Technical Working Subgroup on GTR9 Amendment 3: Status Report

Working Party on Passive Safety (GRSP)

70th Session

06 – 10 December 2021

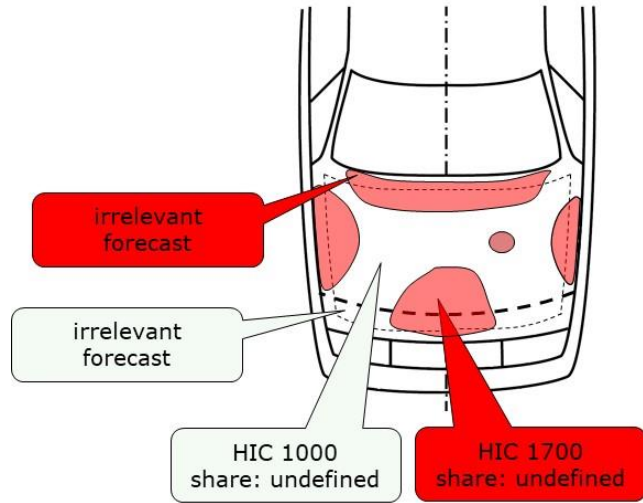
During the meeting it was found that, different to Draft Amendment 3, the US interpretation of UN-GTR9 would allow tests outside the reference lines, but in that case without a need to meet any performance targets (“no requirement zone”).

It was clarified that additional provisions were needed according to the US interpretation, to address contingencies in the current text.

Source: TWSG-03-02

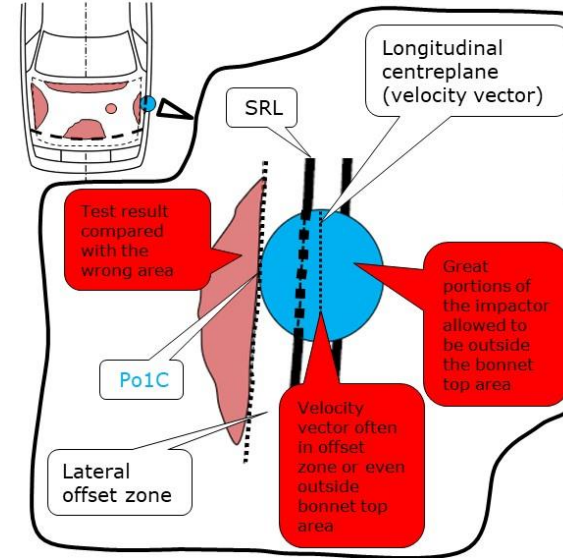
The only two possible interpretations of markup sequence and headform alignment as understood by the majority of group members were compared and possible shortcomings of what was believed being the US interpretation were discussed.

However, it turned out that neither of the two depicted ways of interpretation of UN-GTR9 entirely corresponded to the understanding of the US who read GTR9 in a way that at least two thirds of the bonnet top area must be located in the impact area and zones rather than impact points are to be assessed.

Source: TWSG-03-03

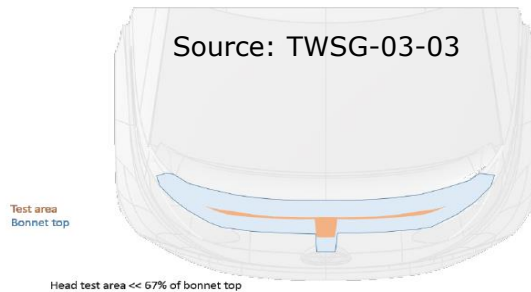
It was demonstrated in the meeting, that those prerequisites cannot always be met. Besides, a "no test zone" for hiding areas as one of the US concerns does not exist.
